**Re: Defect Information Report – Supplemental Report No. 5  
06V-190, FL-476 (phase 2), Tyco Main Cab PDM**

## Subject: PDM Covers

January 2008  
 FL476AB  
 NHTSA #06V-190  
 REVISED BULLETIN

**Fig. 1, View From Underneath the PDM**

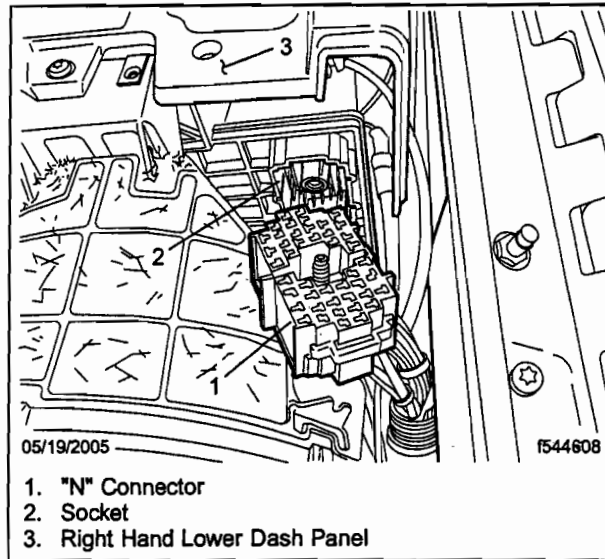
- 1.6 From underneath, remove the "N" connector from the bottom of the PDM (a 9/32-inch socket is required). See **Fig. 1**. Inspect the pins and sockets of both the PDM and the connector for signs of corrosion.

Fig. 2, PDM Cover Installation, Century Class, Columbia, and Coronado Vehicles (left-hand drive)

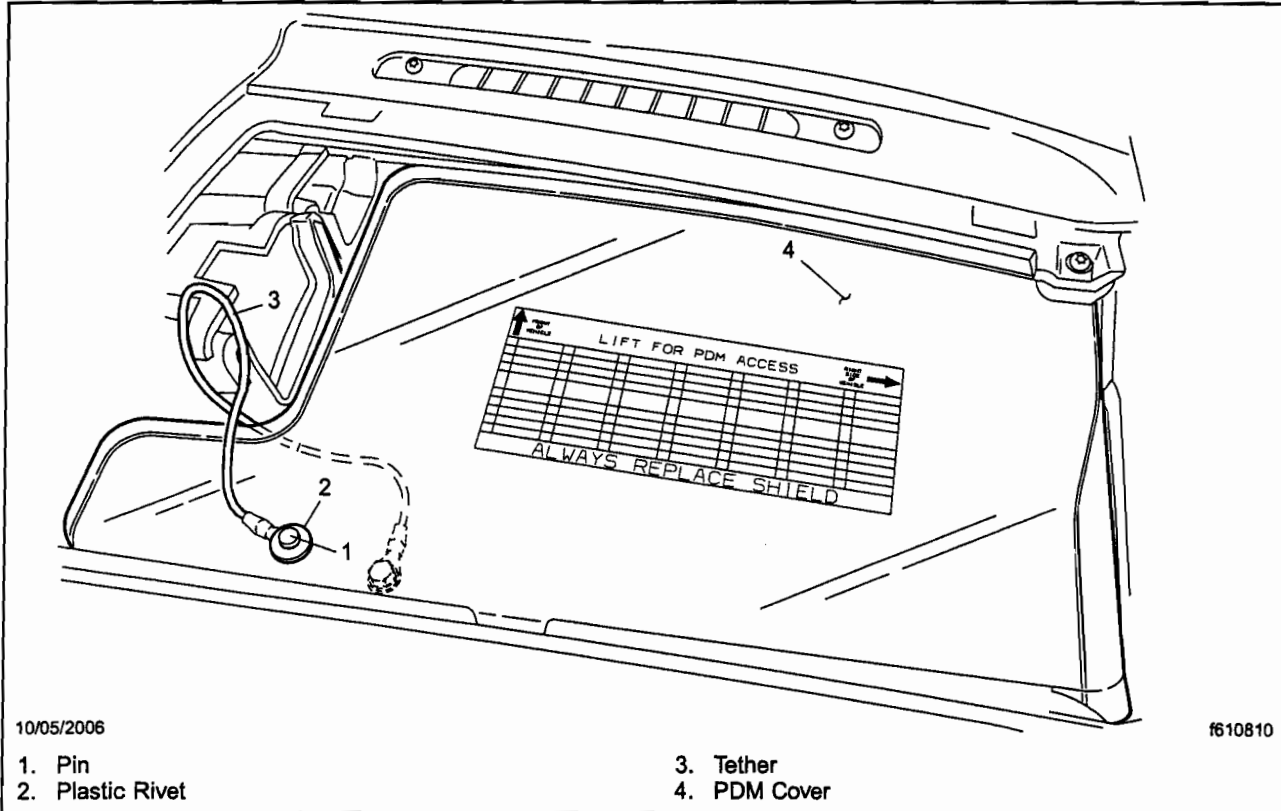
1. Using the previously removed hexnut and washer, attach the tether to the left threaded mounting stud.
2. Position the new cover over the PDM. The cover must be positioned outboard as far as possible to completely cover the battery terminals. The inboard side of the cover should be flush against the HVAC duct, but not under it. See Fig. 2 and Fig. 3.

**Fig. 4, Cross-Section View of Installation, Century Class, Columbia, and Coronado Vehicles (left-hand drive)**

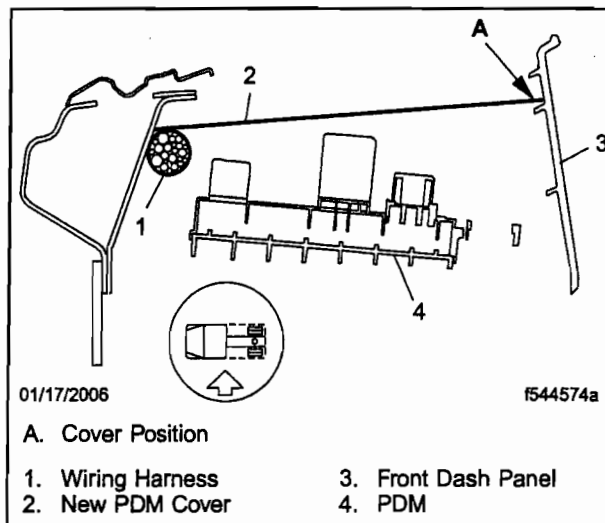
The edge of the cover that is close to the windshield should sit on top of the wiring harness. The edge of the cover that is close to the dash should rest on the second ledge of the inside surface of the front dash panel. See Fig. 4 for a cross-section view of the installation. Ensure that all the PDM wiring is protected underneath the new cover.

**Fig. 5, Dash Panels (left-hand drive shown)**

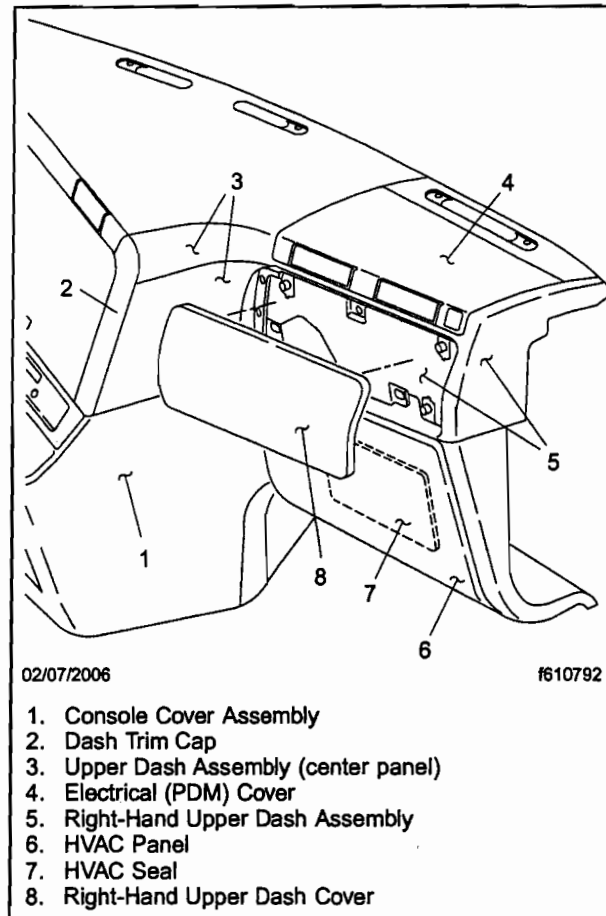
1. From inside the cab, remove the necessary dash panels to gain access to the top and bottom of the PDM. See Fig. 5.
  - 1.1 Remove the electrical (PDM) cover.
  - 1.2 Remove the right-hand upper dash cover.
